CONSTRUCTION PLANS FOR FIAT OF WILMINGTON 6421 MARKET STREET

RE: Fiat of Wilmington
Response to TRC Comments

11-15-12 PLANNING COMMENTS

EXISTING SITE
 SCALE 1" = 50'

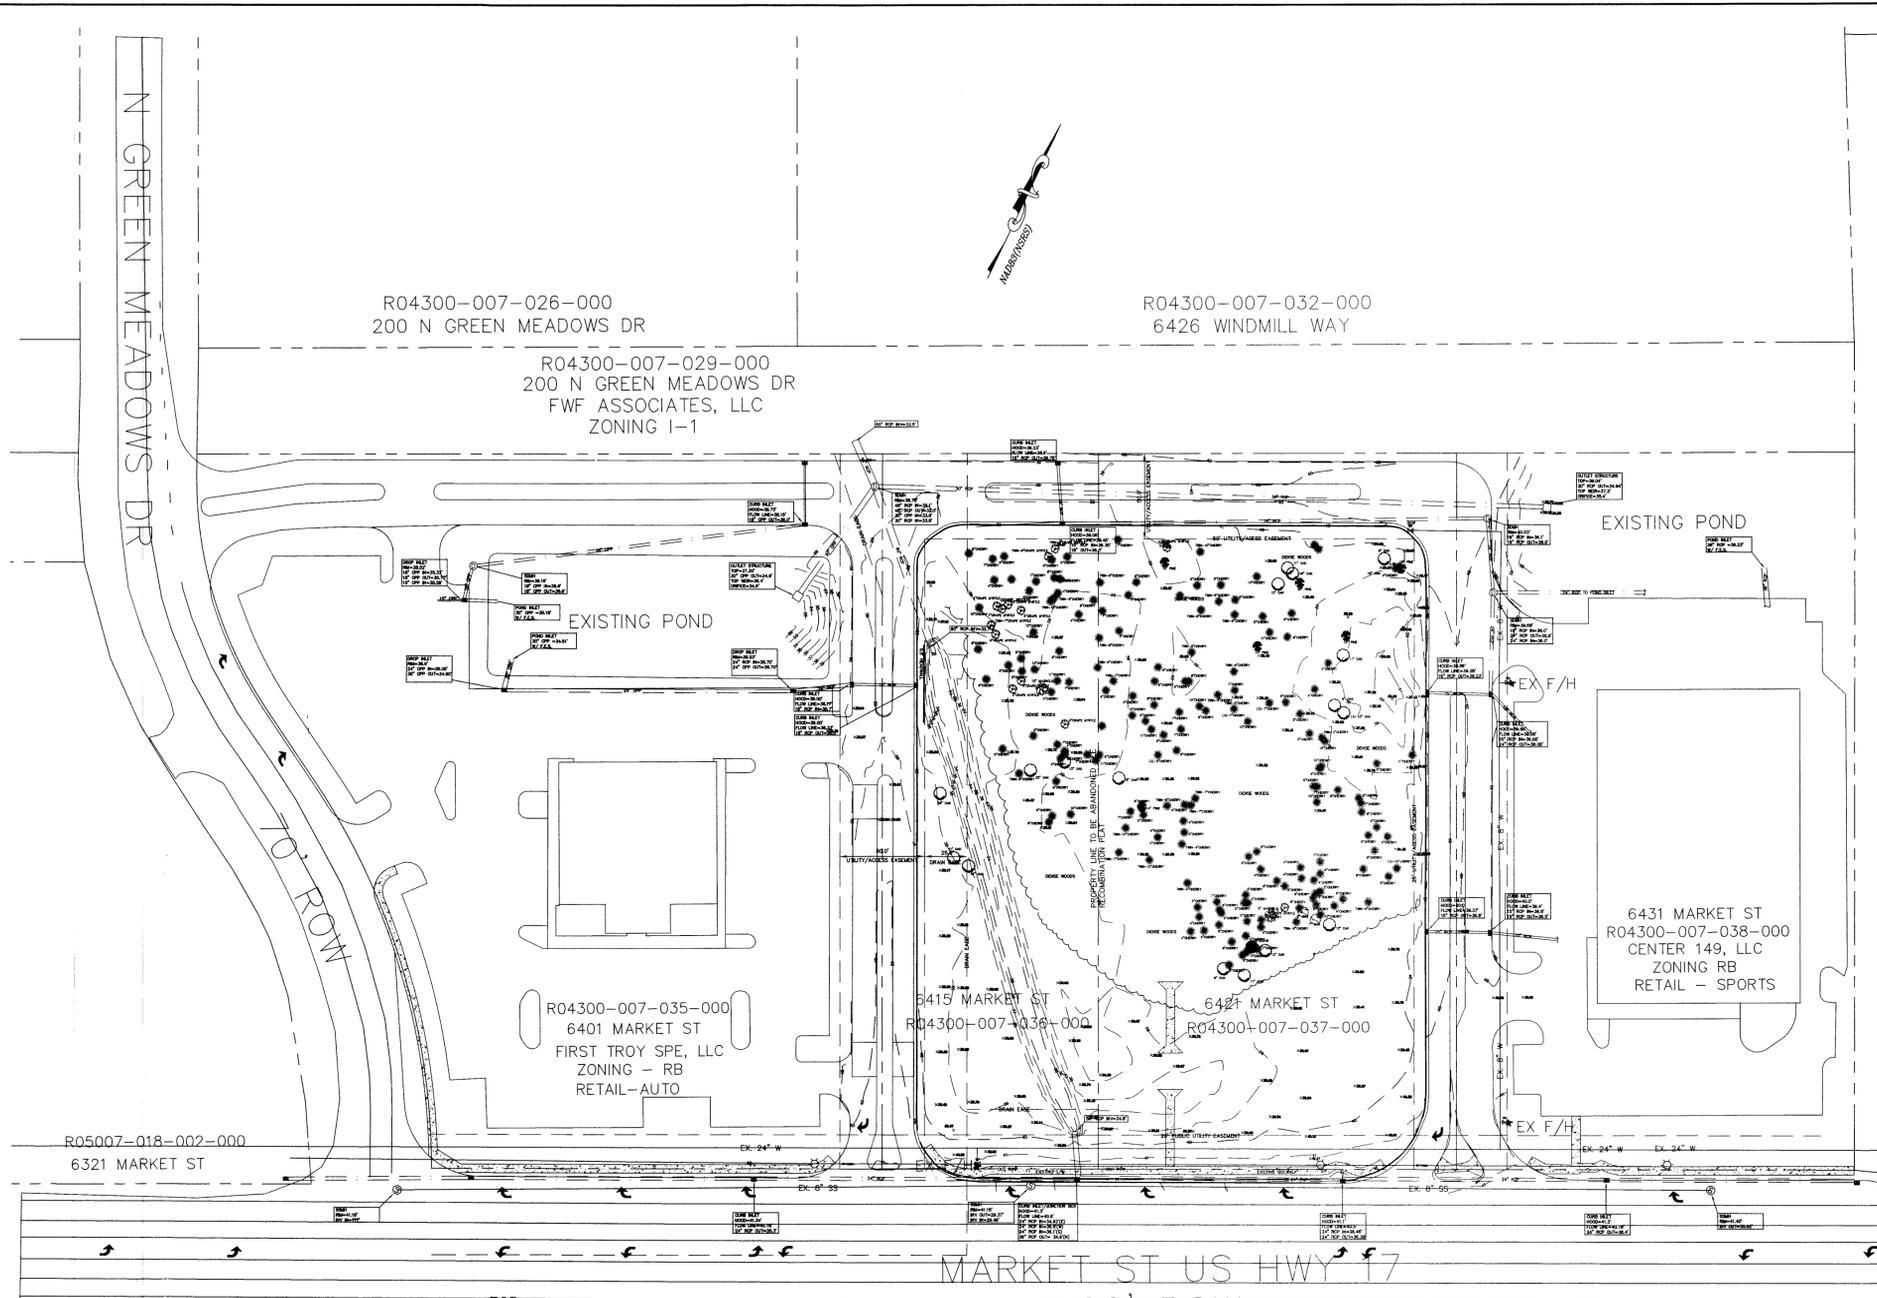
1. Please verify the presence/absence of wetlands on the site. Our records indicate the presence of isolated wetlands extending across a portion of the site. Please delineate any conservation resources and any resource setbacks on the site, in accordance with Article 6, Division III, Conservation Resource Regulations, 18-341.

NO WETLAND WITHIN PROJECT AREA

SITE PLAN
 SCALE 1" = 30'

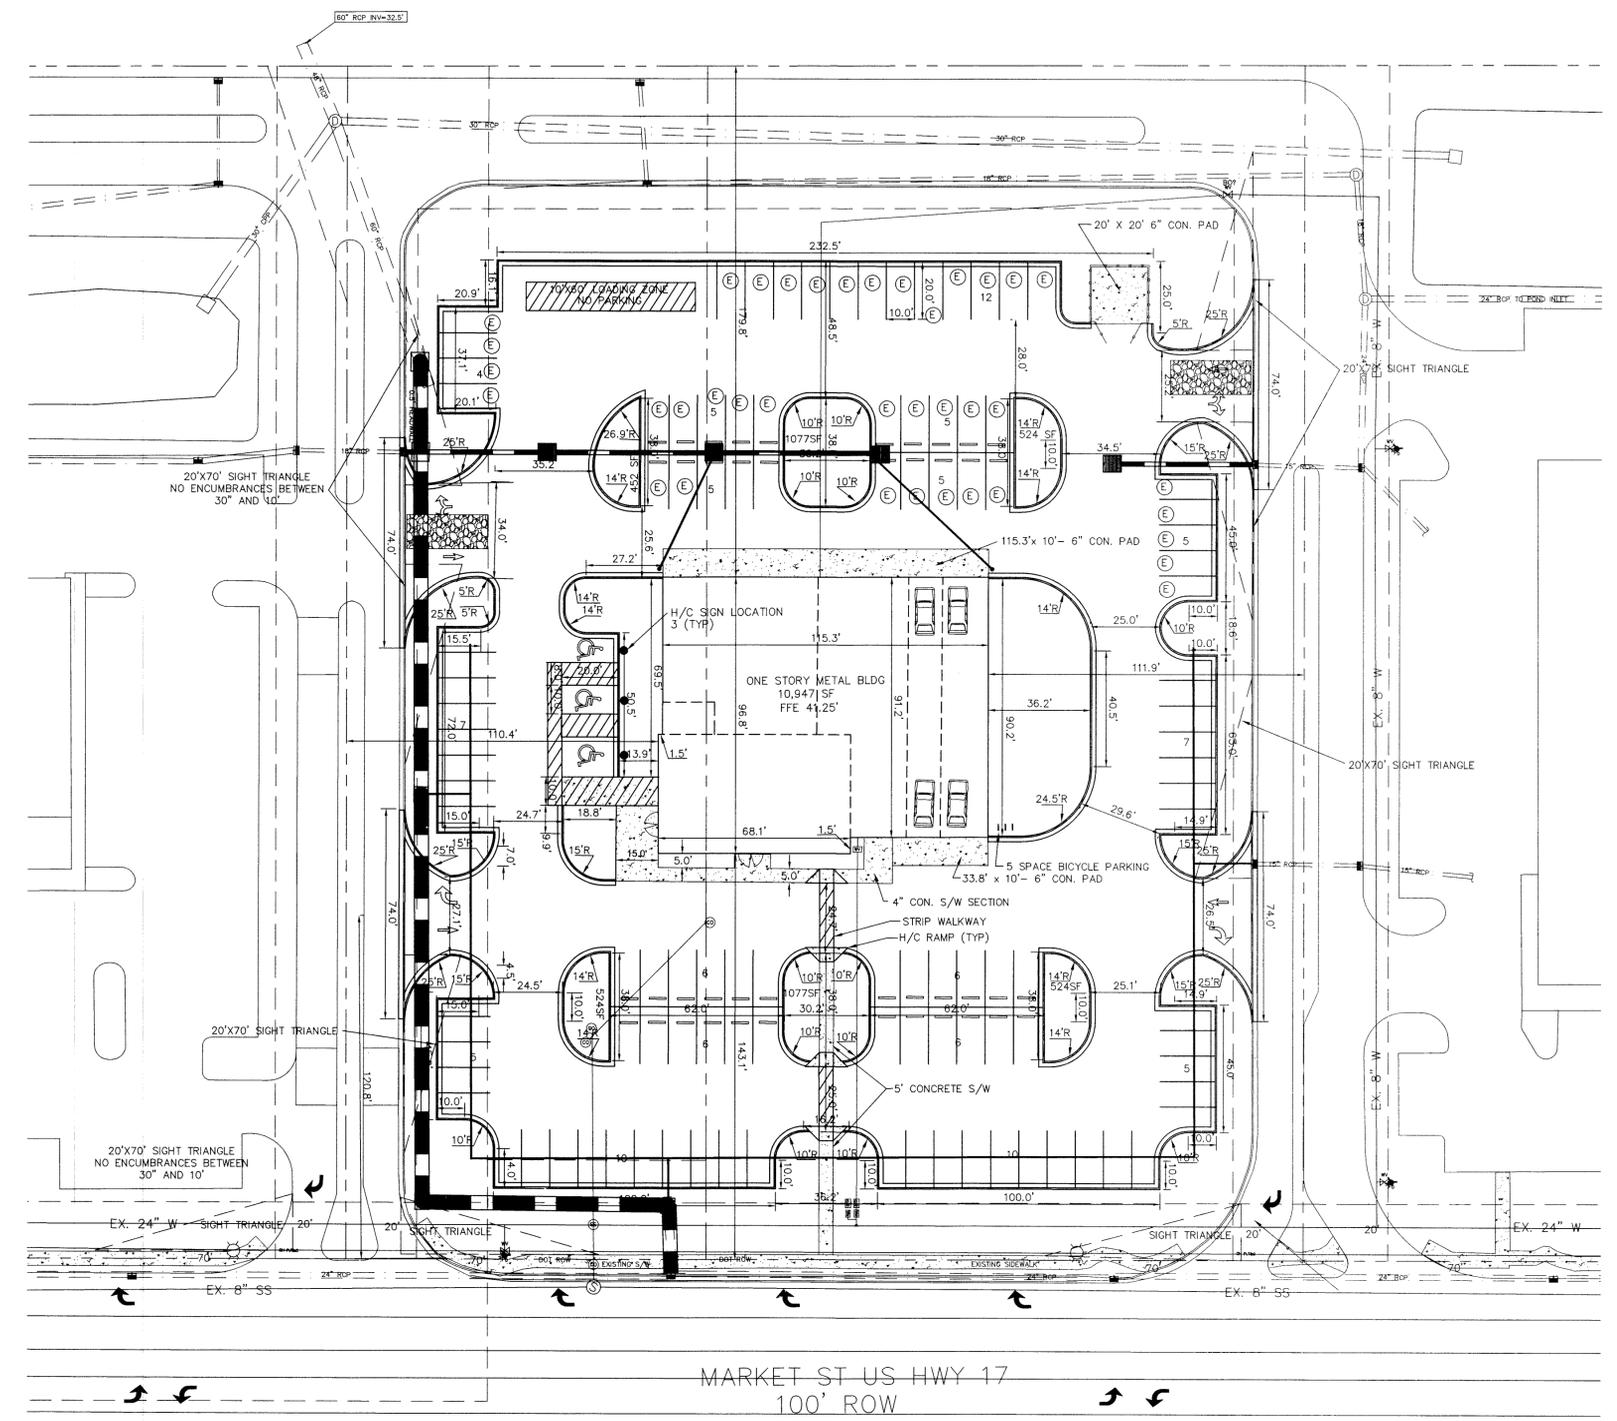
3. Provide thermoplastic pavement markings at all driveways.

6. Provide a sidewalk connection between the site and the public sidewalk.

15. Please show location of handicap signs on the site plan.

See note 8 - Proposed turn arrows are shown on Sheet C2.

Sidewalk has been added to plans complete with h/c access.

LOCATION OF H/C SIGNS SHOWN ON SHEET C2.

GRADING PLAN
SCALE 1" = 30'

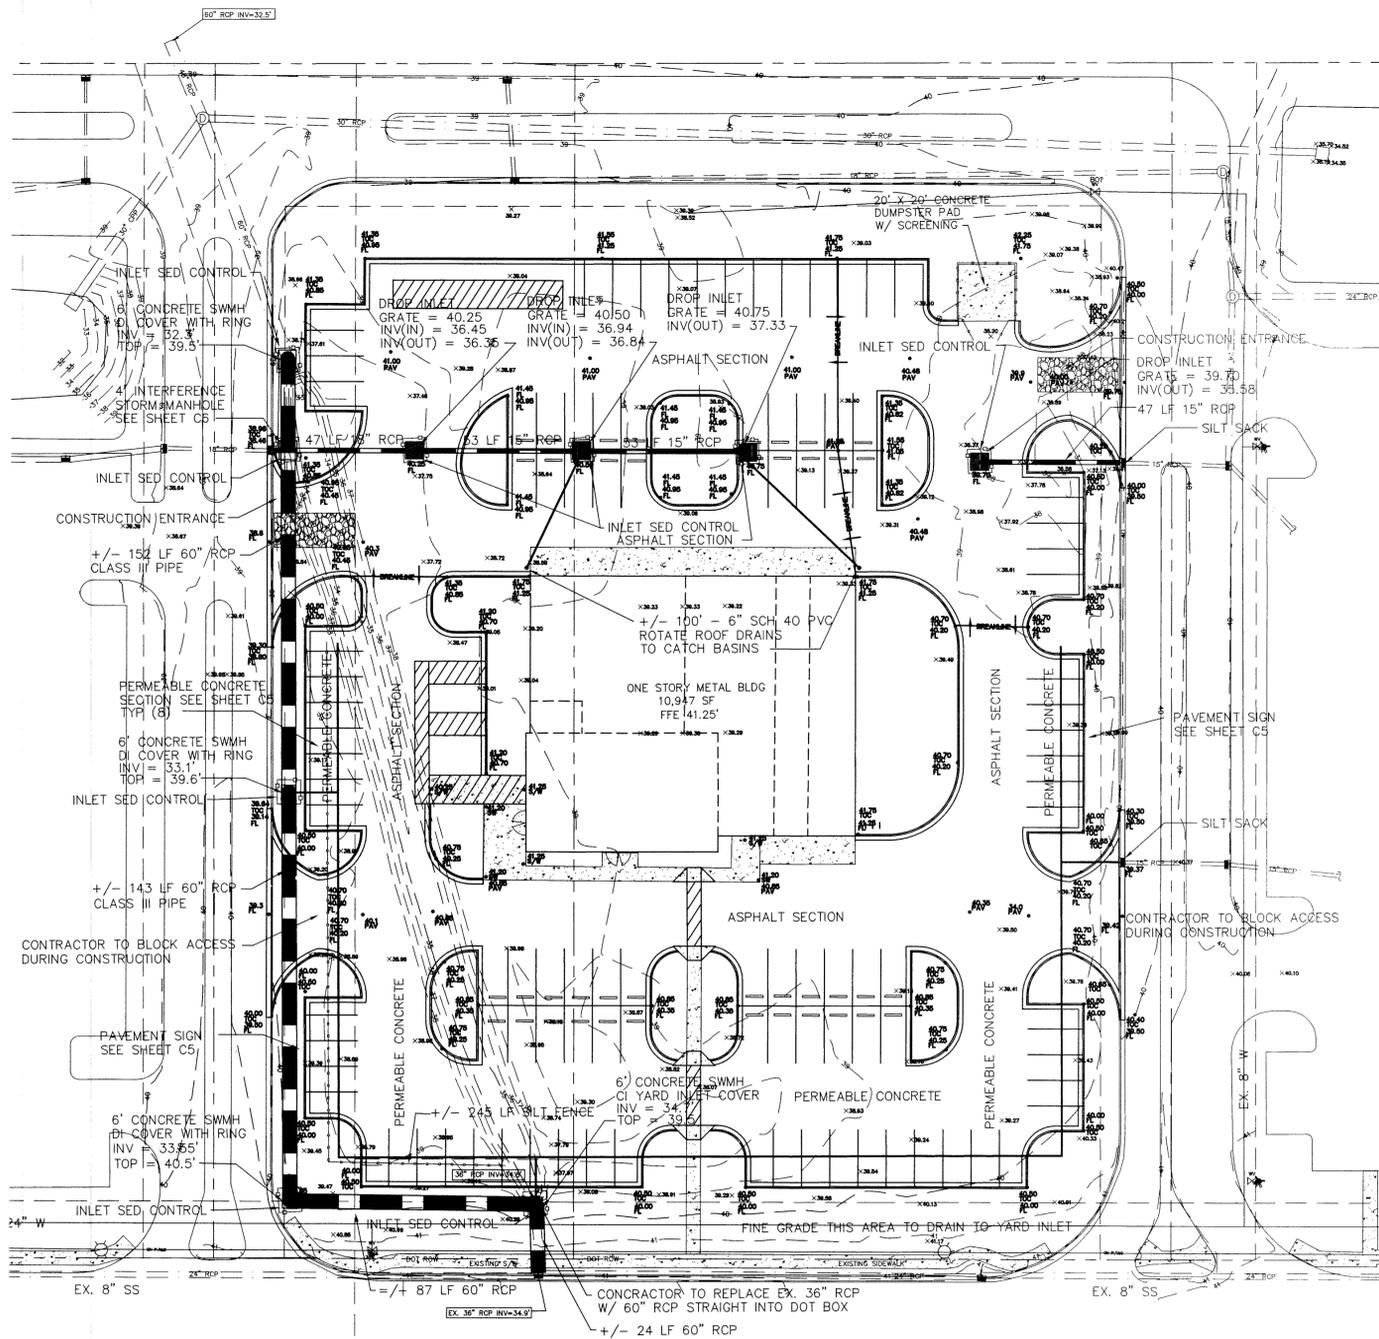
2. Show proposed driveway centerline elevations at both the front and the back of each concrete driveway apron, at the curb line, property line & points at 26' and 52' behind the property line. (Chapter VII, C(1)(a)(2)12 CofWTSSM)

See Sheet C3. Spot elevations shown at curb line (which is +/- 23' from pl), and 52'. We are not proposing the standard concrete driveway apron on any of the four private drives off a private drive. This was discussed by phone on 12/4/12

WHEEL STOP DETAIL
NOT TO SCALE

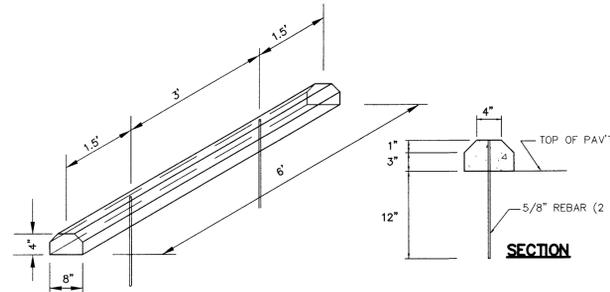
18. Wheelstops are to be a maximum height of 4". Please revise the detail on sheet C6.

DETAIL MODIFIED
